# 2001-0177

Waldron Way- Lot 14  
Project Name/Description

The Planning Department has received your application for the construction of a 15,000 square foot machine shop at 68 Waldron Way. After review of the submitted plans and materials, the following comments have been generated:

RE: 68 WALDRON WAY SITE PLAN

LIGHT POLES  
68 WALDRON  
WAY

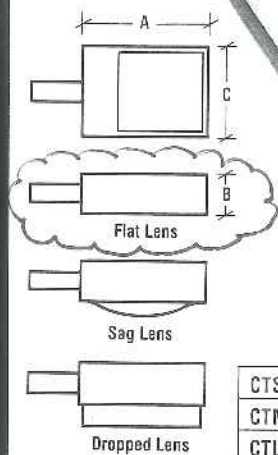
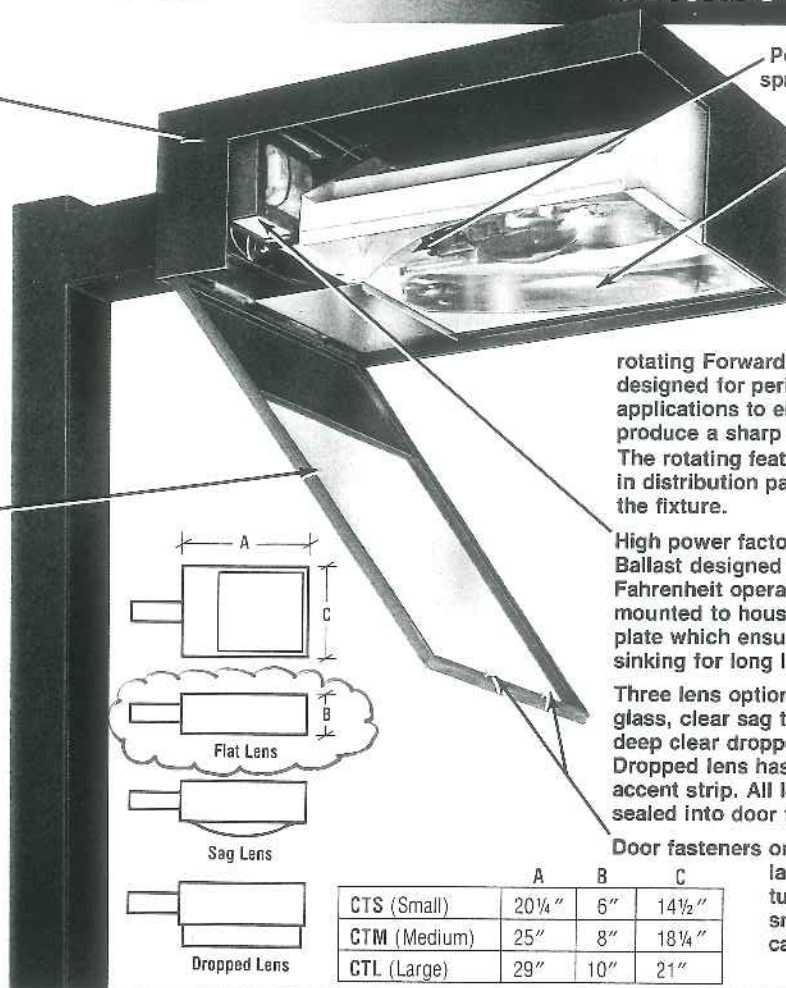
5. A photometric plan and catalog cuts for the proposed fixtures including pole heights is needed.
6. An enclosure around the dumpster should be provided.

Per the condition of approval in your September 24, 2001, letter, I have revised the lighting on Drawings C2 and C5. Nine copies are enclosed for your records. The other drawings remained unchanged. Wall-mounted and pole-mounted fixtures have been specified that meet the Technical Design Standards. Updated photometrics and catalog cuts are also included for your review.

1. All references to future building and parking have been removed from the drawings.
2. I have revised the light pole detail per your request. Catalog cuts are included for your review. I have also included sample cuts for the wall-mounted lights.
3. Photometrics were included on the previous drawing, and have been updated for the new fixtures.
4. The plant list has been revised per Jeff Tarling's request.
5. The previously approved 30-foot preservation area along the back of the property is shown on all the plan views, and drawing C3 shows the limit of clearing line.

Cambridge direct gas-fired industrial heater, AGA certified to meet ANSI Z83.18a

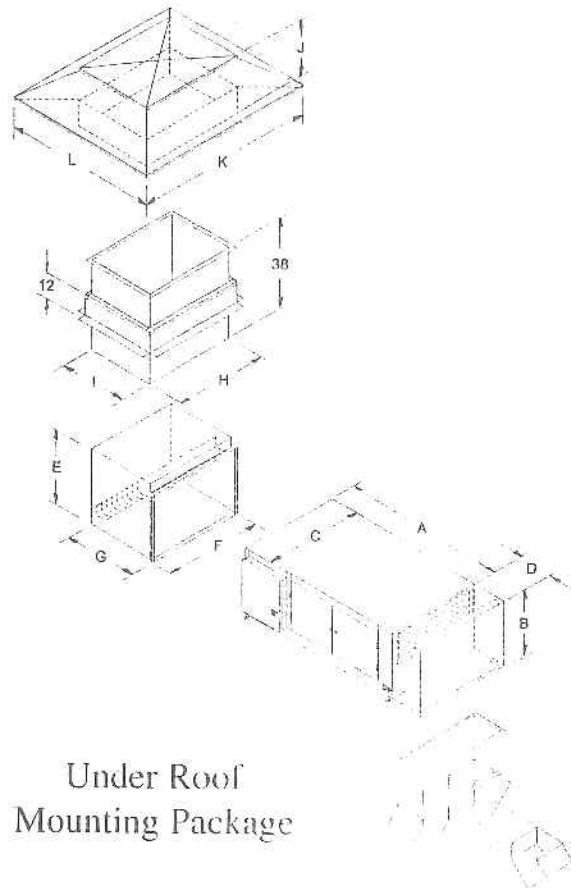
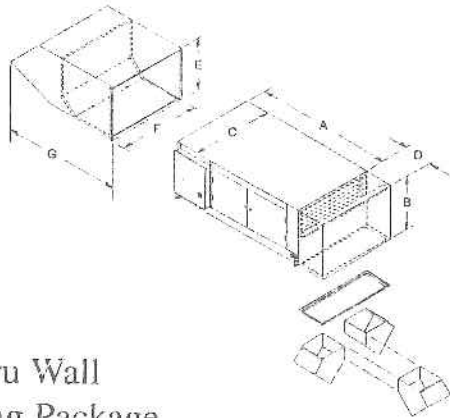
8. Will there be an LP Gas supply and/or underground fuel oil tank? The location of the mechanical room was not clear on the plan. If rooftop mechanical units are proposed then data must be provided for staff review.
9. Staff recommends the inclusion of additional street trees to enhance the overall landscape plan.
10. Is appropriate signage along Waldron Way indicating the occasional reverse movement of semi-trailers being proposed?

Drainage Diagram for 01143

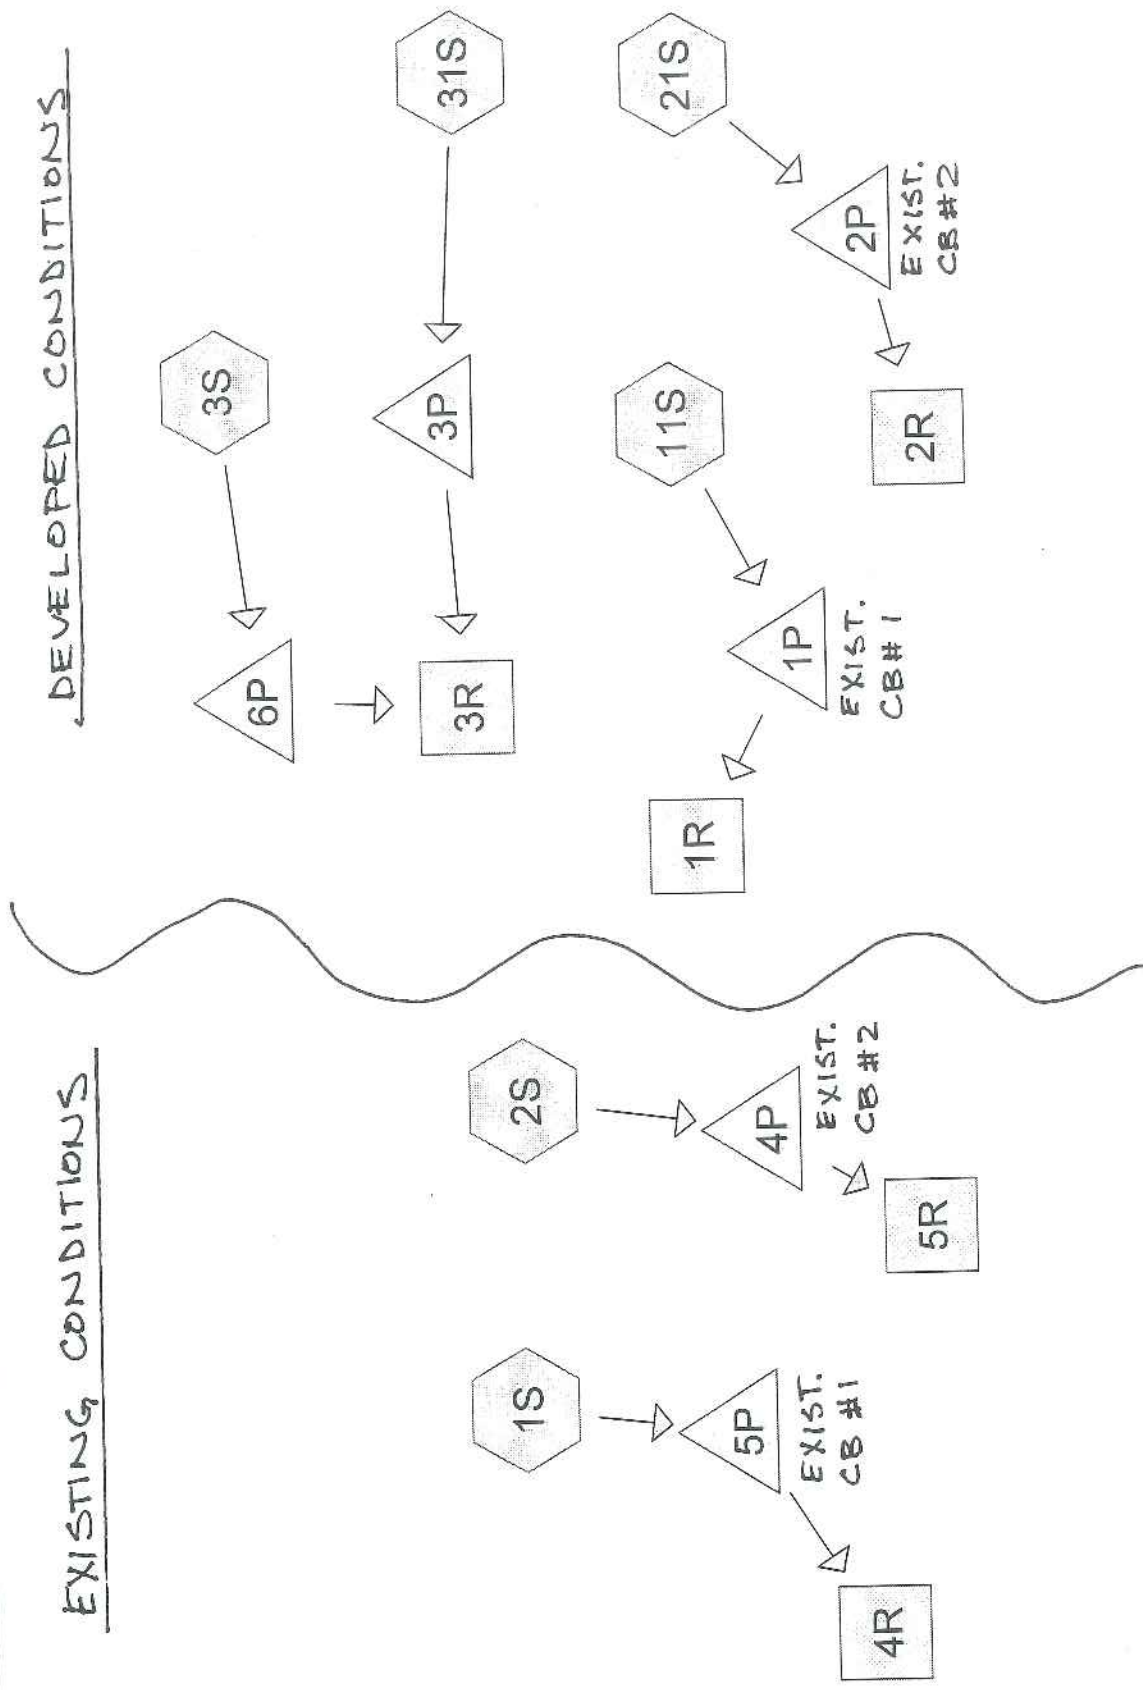
4. Should some signage indicating the occasional reverse movements of semi-trailers into the loading dock be placed on Waldron Way?
5. The applicant should provide a brief drainage summary and rational method computations supporting the drain pipe sizing and adequacy of the catch basins and existing storm drain in Waldron Way.
